CHILDREN'S HOSPITAL OF ORANGE COUNTY

**INTERIOR SIGNAGE &
5 STORY GARAGE SIGNAGE**

Fabrication & Installation - Vomar Products, Inc.

Fabrication Drawing

Sheet Number 2.0

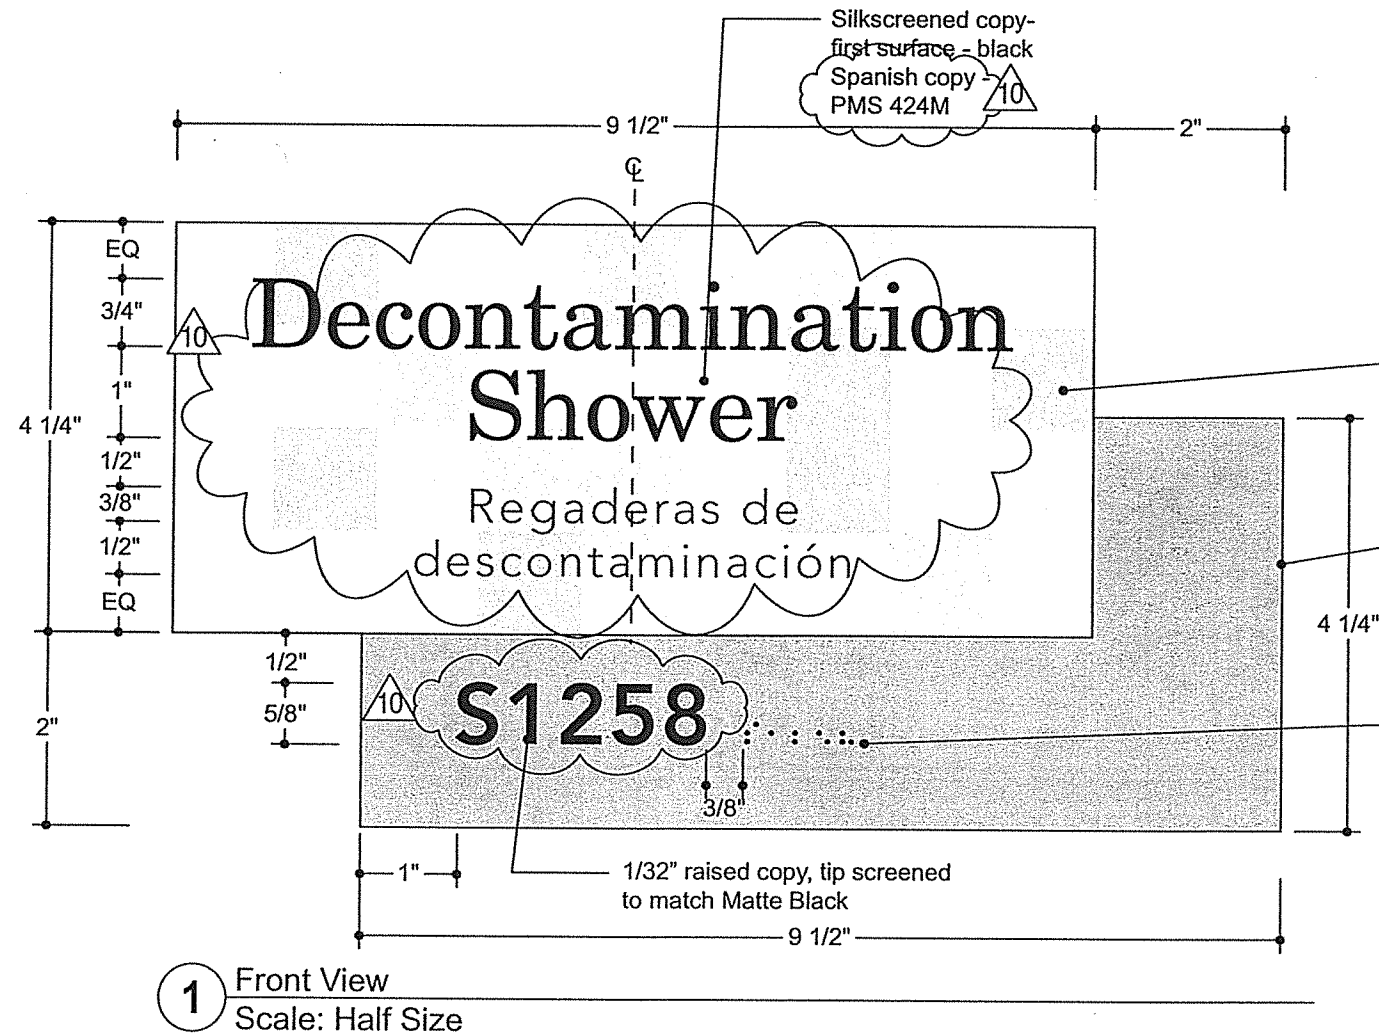
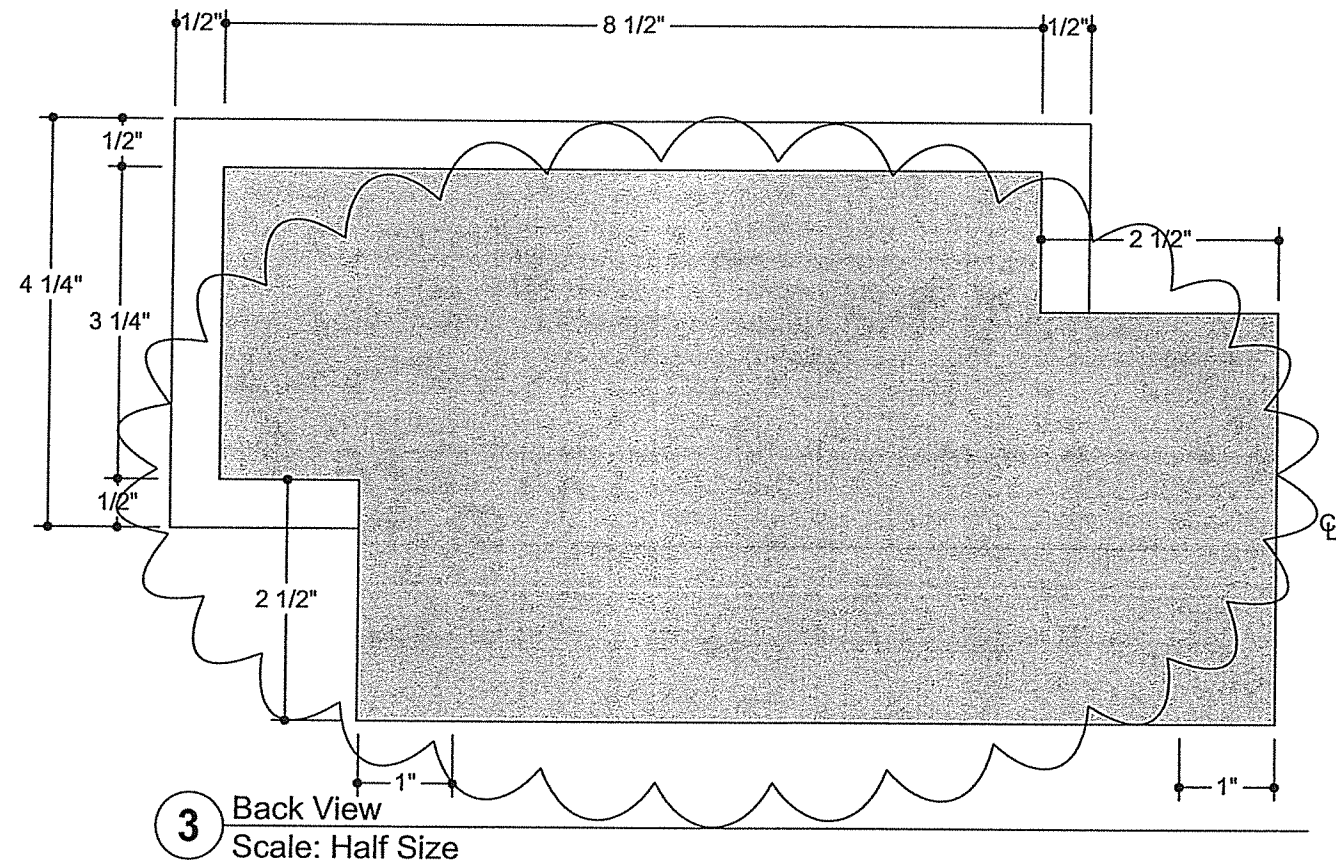
- GENERAL NOTES**
1. Eliminate visible adhesive @ rear acrylic and face acrylic perimeter.
 2. Mosaic pattern & BACK PAINT to be consistent & not chipped at edges.
 3. Paint at braille ball to be EVEN (Not indents in paint around balls)
 4. Upper acrylic to have smooth laser cut (sample had striations around perimeter).

Sheet Number 3.0

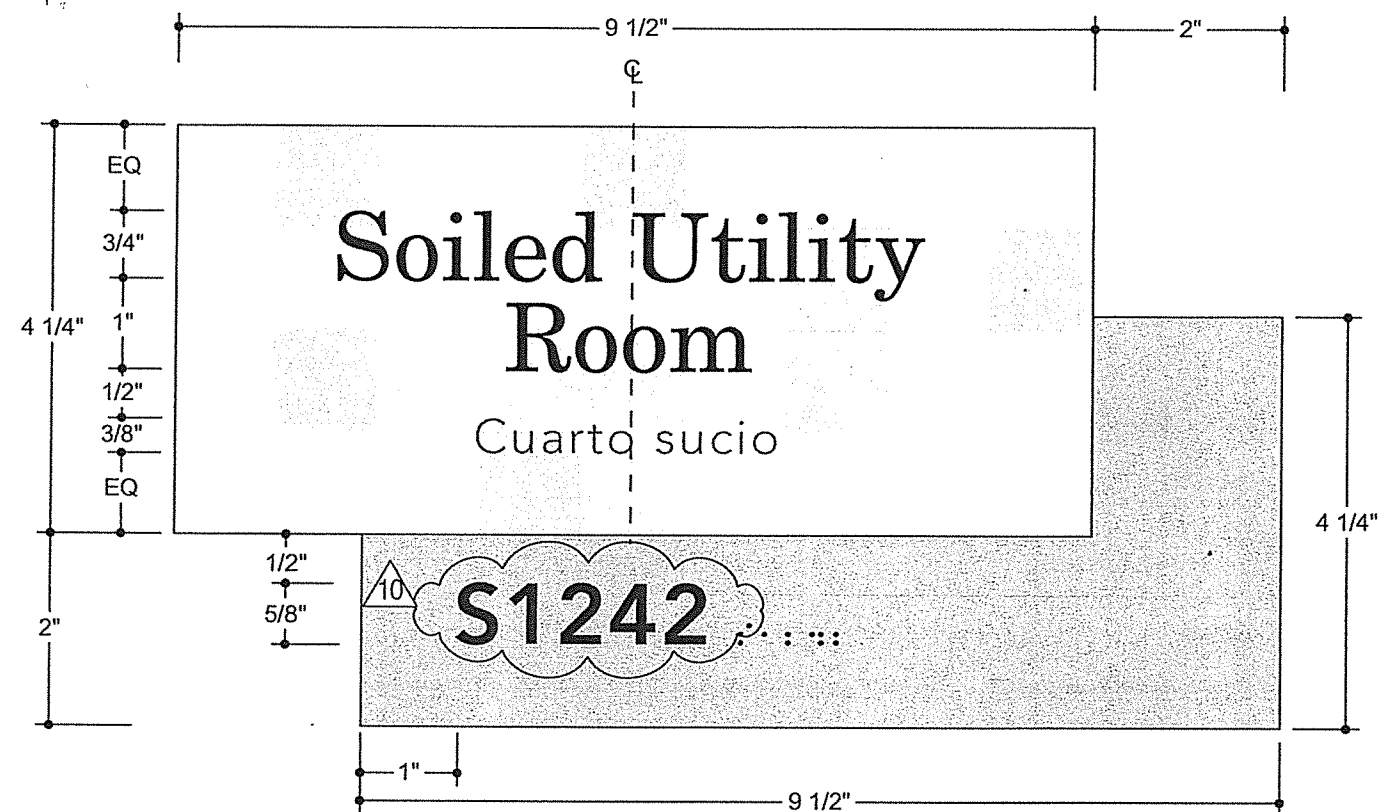
1. Eliminate visible adhesive @ rear acrylic and face acrylic perimeter.
2. Mosaic pattern & BACK PAINT to be consistent & not chipped at edges.
3. Paint at braille ball to be EVEN (Not indents in paint around balls)
4. Upper acrylic to have smooth laser cut (sample had striations around perimeter).

1 Front View
Scale: Half Size

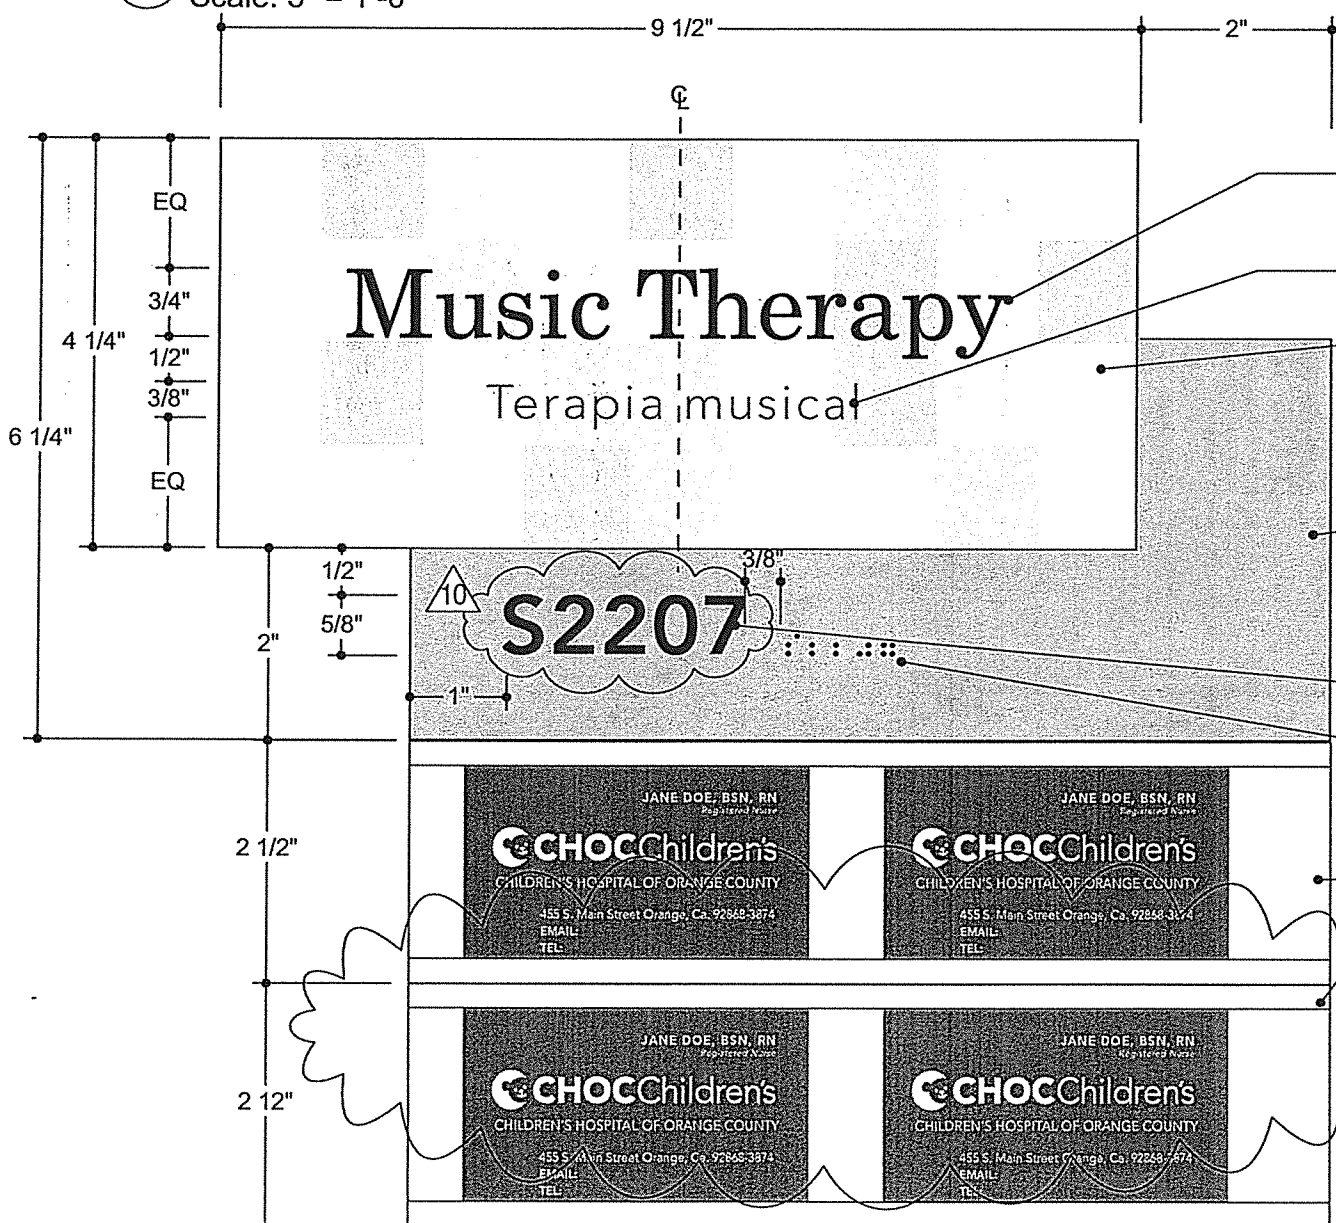
PROVIDE IN HOUSE
SAMPLE OF 2 1/4" CARD
HOLDER FOR APPROVAL

Sheet Number 5.0

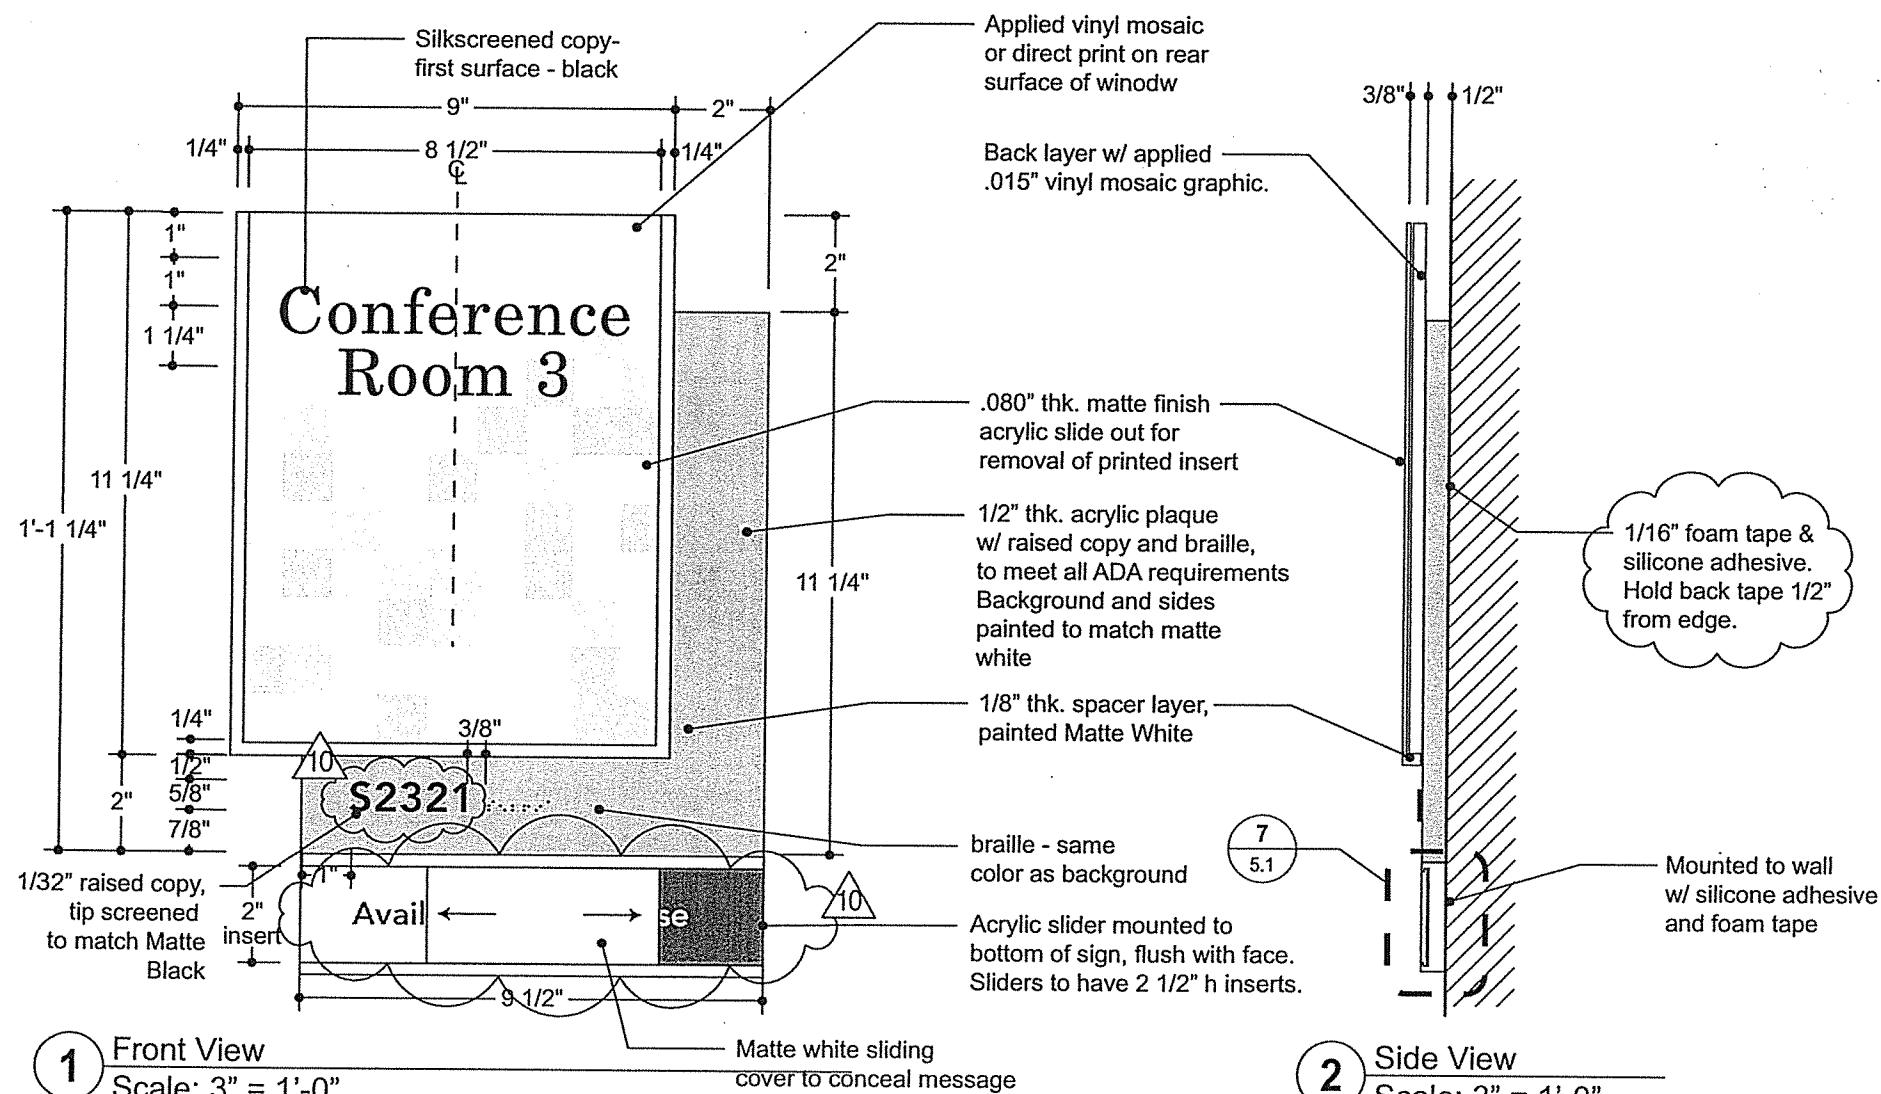
1. Eliminate visible adhesive @ rear acrylic and face acrylic perimeter.
2. Mosaic pattern & BACK PAINT to be consistent & not chipped at edges.
3. Paint at braille ball to be EVEN (Not indents in paint around balls)
4. Upper acrylic to have smooth laser cut (sample had striations around perimeter.)

Sheet Number 7.0

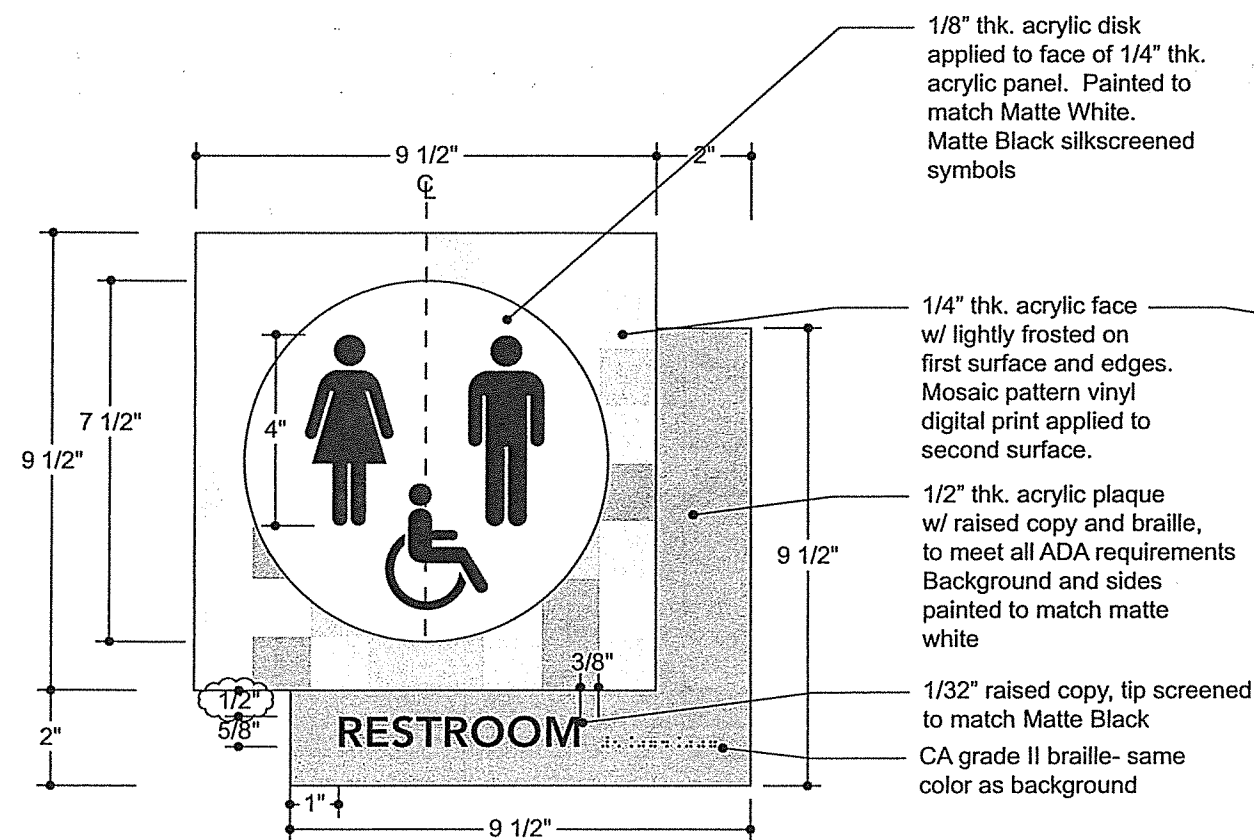
- GENERAL NOTES**
1. Eliminate visible adhesive @ rear acrylic and face acrylic perimeter.
 2. Mosaic pattern & BACK PAINT to be consistent & not chipped at edges.
 3. Paint at braille ball to be EVEN (Not indents in paint around balls)
 4. Upper acrylic to have smooth laser cut (sample had striations around perimeter).

Sheet Number 17.1

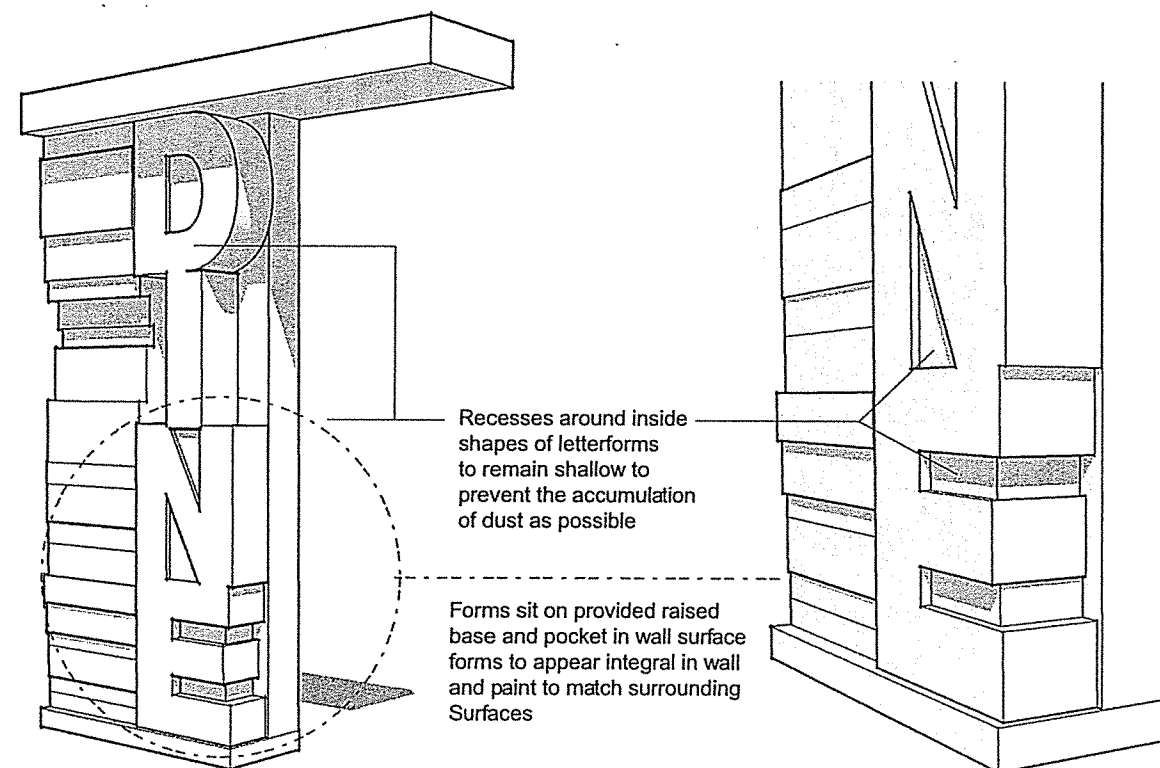
NEW COLOR -
PROVIDE SAMPLE FOR
IN HOUSE REVIEW.
FRAZEE WEAVERBIRD
7760W

DELETED ¹⁴
